Product Change Notification

Change Notification #:	20130501M-01
Change Title:	AX742 V1H2 Stacking Kit: silent transition and version change to V1H3
Date of Publication:	May 1st, 2013

NETGEAR ProSafe 24-Gigabit Stacking Kit

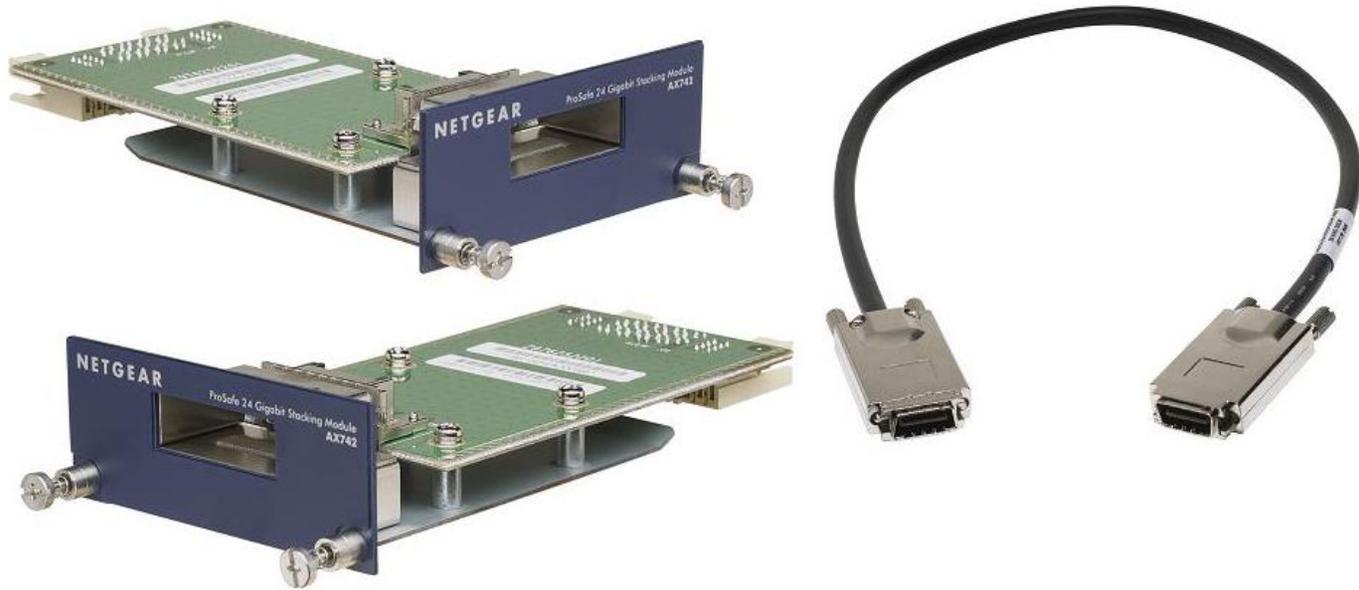
Current Version Material V1H2	**Post-Conversion Material V1H3**
Product Name – Front (I/O Module Overlay)	AX742 ProSafe 24 Gigabit Stacking Kit	AX744 ProSafe 10 Gigabit Ethernet CX4 Module
Serial Number prefix (Stacking Kit Label)	1DDxxxxxxxxxx	39Cxxxxxxxxxx
CX4 Connector on each I/O module	Proprietary CX4 connector with mounting screws	Standard IEEE 802.3ak 10GBASE-CX4 connector
Stacking Cable	Proprietary CX4 connectors with surrounding screws	Standard IEEE 802.3ak 10GBASE-CX4 cable

For mixed operation between previous and new version, customer can remove mounting screws around each previous AX742 I/O module CX4 connector. Except CX4 connector mounting screws difference, previous AX742 I/O module and new AX744 I/O module are identical.
